Vance Jackson IH-10 to Loop 410  
SAWS Water Job No. 18-4002  
and  
SAWS Sewer Job No. 18-4523

SAWS Solicitation No. CO-00193

ADDENDUM No.2

June 25, 2018

**1 SURFACE REHAB STA. 0+00 TO 2+02**  
SCALE: 1" = 40'

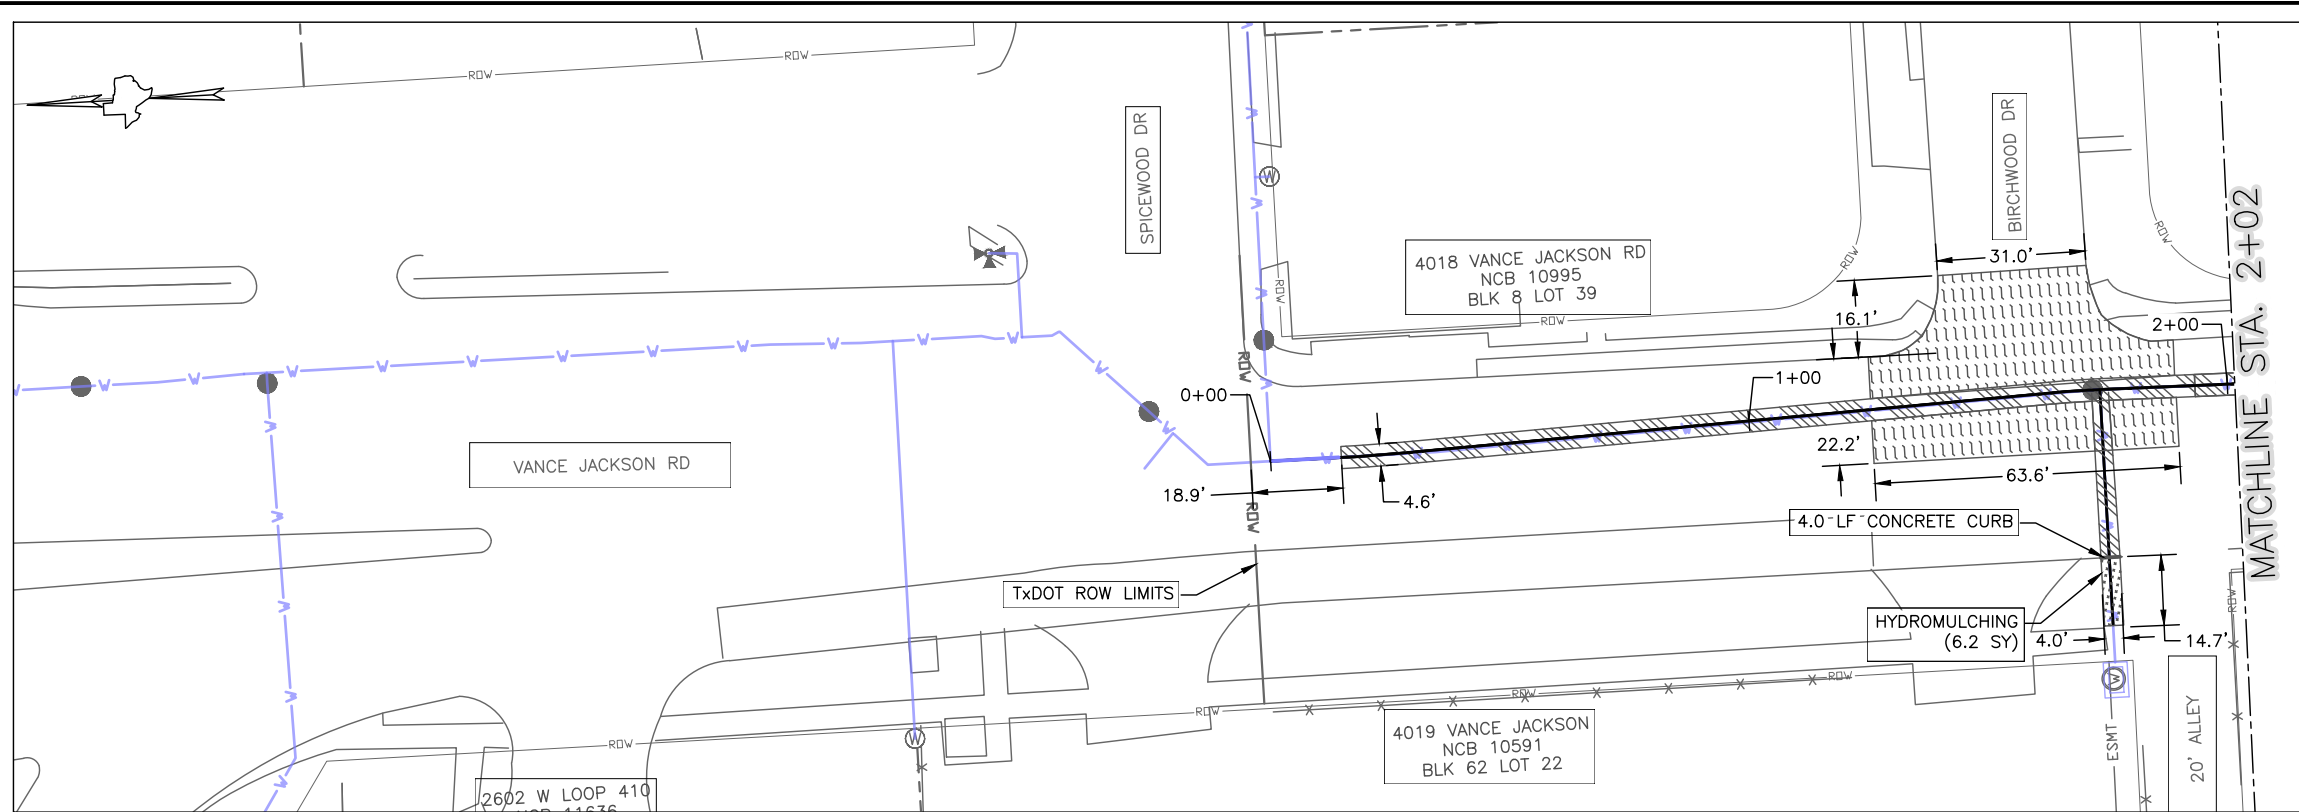
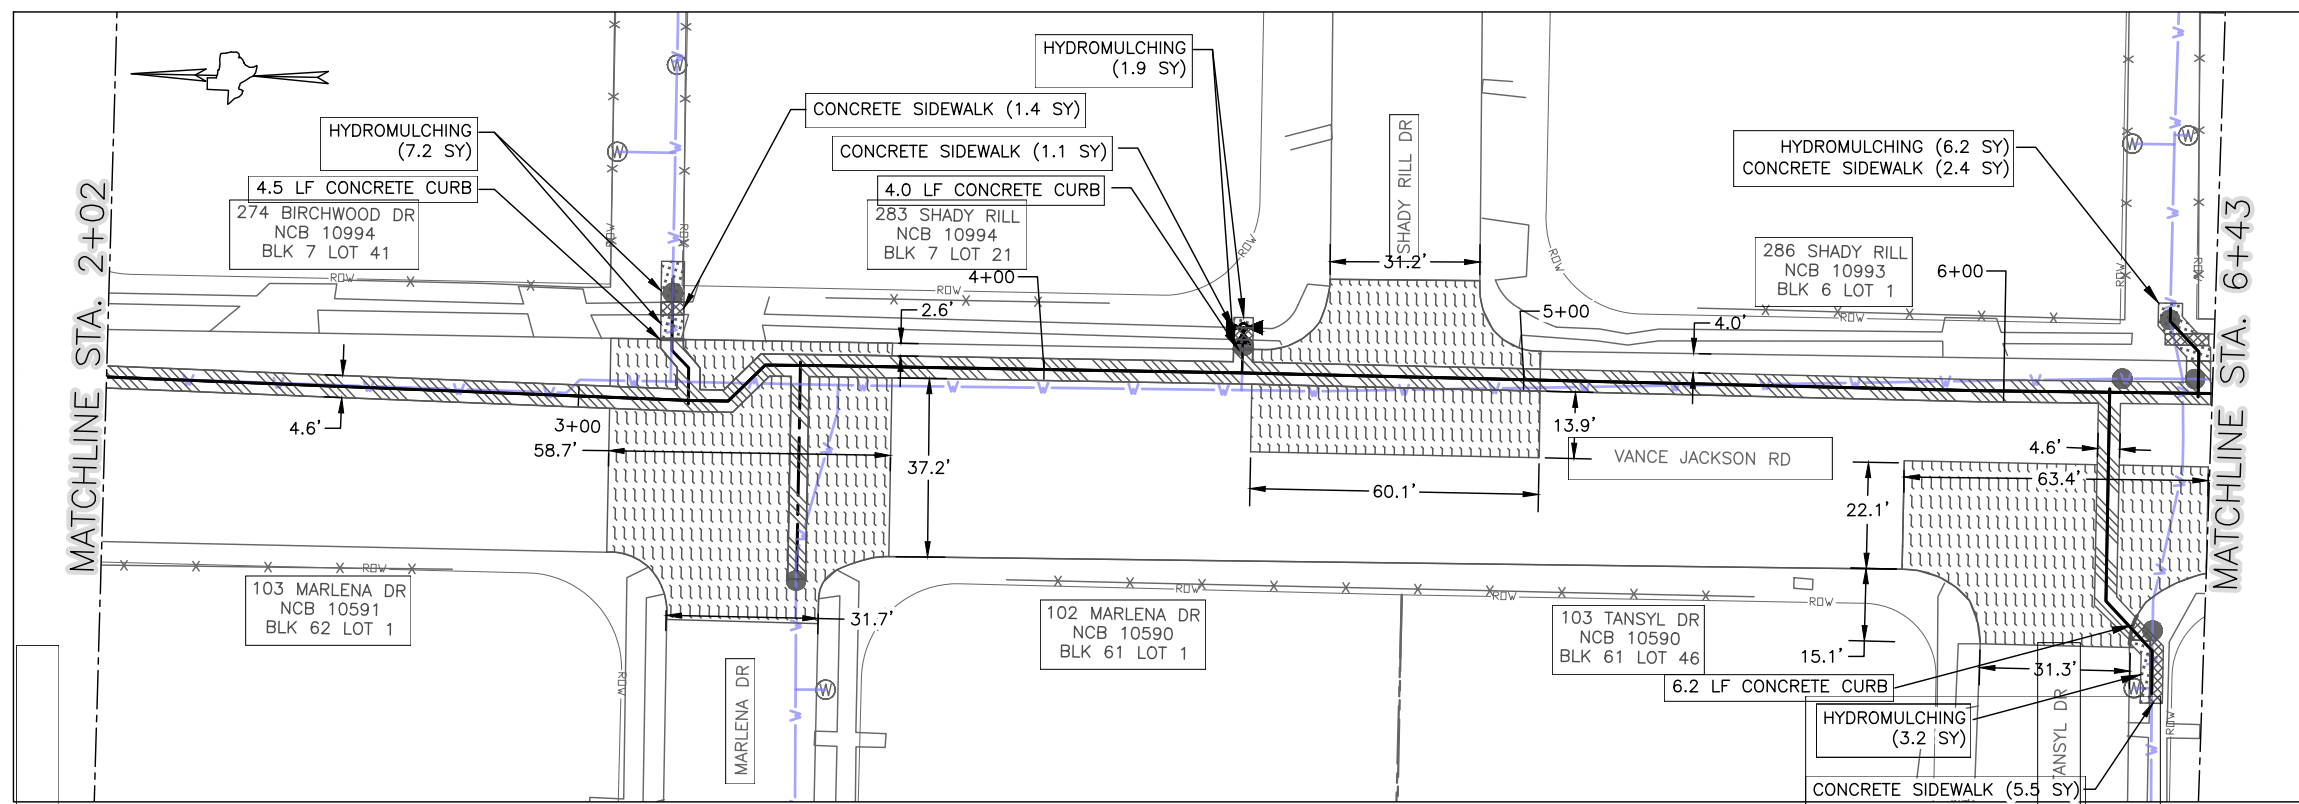
19. On plan sheets 38,39,42,44 & 46 the plans show a distance from existing curb to edge of proposed trench. Will SAWS provide this same information for sheets 37,40,41 & 45 so we can determine if the existing curb can be salvaged or if an excavator track will be crushing it because of the close alignment?

1. Sheet 37 added additional labels between proposed trench limits and the existing curb.
2. Sheet 40 added additional labels between proposed trench limits and the existing curb.
3. Sheet 41 added additional labels between proposed trench limits and the existing curb.
4. Sheet 45 added additional labels between proposed trench limits and the existing curb.

*Sheet 37, 40, 41, & 45 have been revised to provide the dimension between the existing curb and edge of proposed trench. Sheets are included with Addendum 2.*
